# VALIDATION REPORT

**Kuyucak 25.6 MW Wind Farm Project, Turkey**

<b>Subject:</b>				
Validation pursuant to Art. 12 of the Kyoto Protocol and Gold Standard requirements				
<b>Validation Team:</b>				
Dr. Jochen Gross – Lead Assessor Aslihan Cetin - Local Assessor Sectoral Scope Expert- Karen Tong Dina Bauer – Assessor		<input checked="" type="checkbox"/> No Distribution (without permission from the Client or responsible organisational unit)		
<b>Technical Review:</b>	<b>Trainee Technical Reviewer:</b>			
Date: 28/04/2009 Name: Irma Lubrecht	Name: Not Applicable	<input type="checkbox"/> Limited Distribution		
<b>Authorised Signatory:</b>				
Name: Siddharth Yadav Date: 18 <sup>th</sup> November 2010		<input type="checkbox"/> Unrestricted Distribution		
<b>Revision Number:</b>	<b>Date:</b>			<b>Number of Pages:</b>
0	11/12/2008			92
1	17/03/2009	94		
2	06/05/2009	86

Figure 2. Single line layout for the Çataltepe 16 MW wind farm

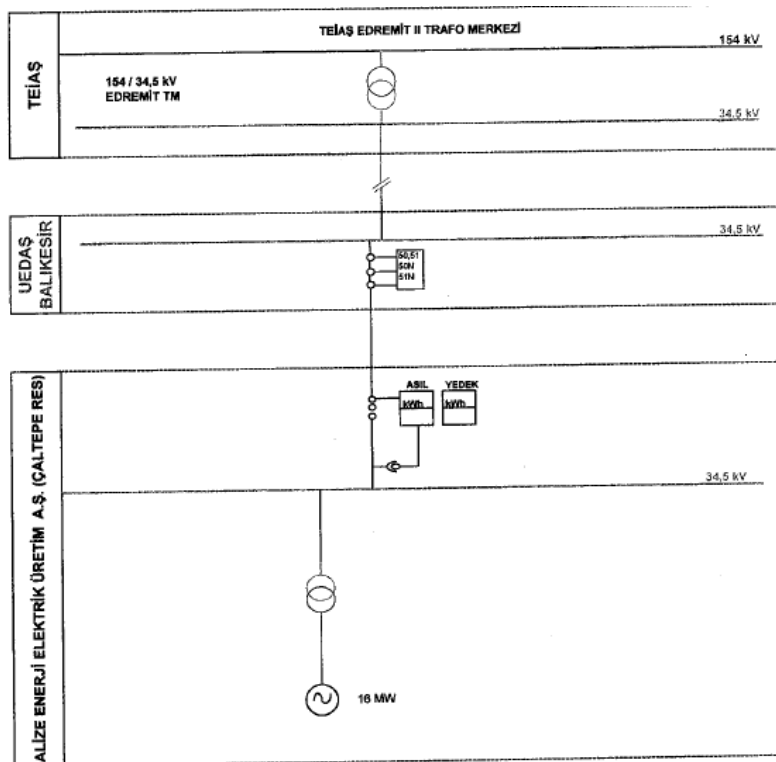
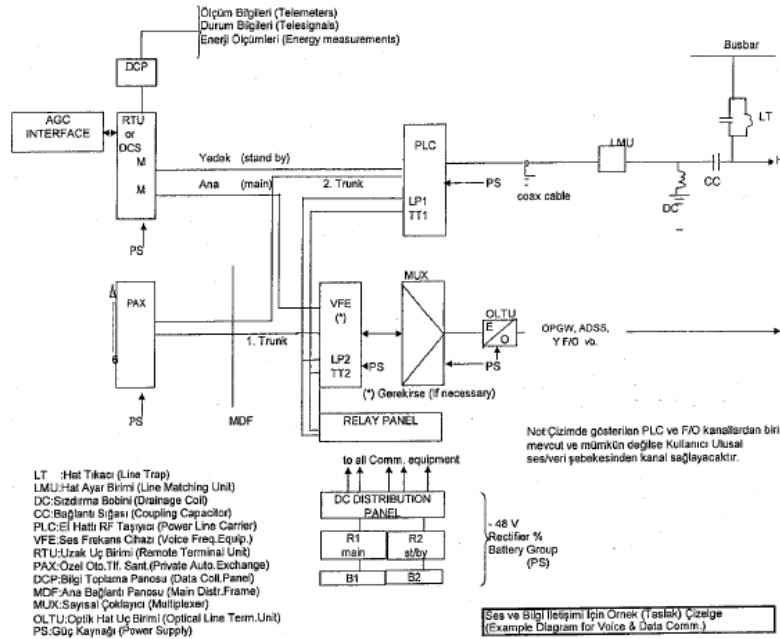
Date:	05/08/2008			Raised by:	SGS		
No.:	4	Type:	CAR	Issue:	Monitoring plan and corresponding procedures are insufficient	Ref.:	B.11.1-3, B.11.5, B.12.1-2, B.13, F.1.1.2
Lead Assessor Comment					Date: 05/08/2008		
<p>a. SD indicators are not included in monitoring, please add to revised monitoring plan</p> <p>b. Competences, responsibilities not defined, please add to revised monitoring plan</p> <p>c. Day-to-day record handling and archiving not defined, please add to revised monitoring plan</p> <p>d. Fall back options, emergency preparedness, default values and potential data adjustments, not defined, please add to revised monitoring plan</p> <p>e. Report templates not defined, please add as e.g. demonstrated for the recent project Mare Anemon</p> <p>f. monitoring of self-consumption is missing, please add to monitoring plan</p> <p>g. description insufficient, please describe monitoring methodology in more detail</p> <p>h. uncertainty is missing, please add</p> <p>i. QA/QS system not treated, e.g. training, internal auditing, implementation of improvements, reviewing, please explain QA/QS system (for all parameters)</p>

A single-line connection plan for the Çataltepe 16 MW wind farm is given below. Final connection plans for other projects are not finalized yet, however the same technical layout applies for them as well. Two measurement devices measure the electricity generation and consumption and afterwards the generated electricity is supplied to the transformer station, after which the transmission line connects to the medium- or high-voltage electricity grid.
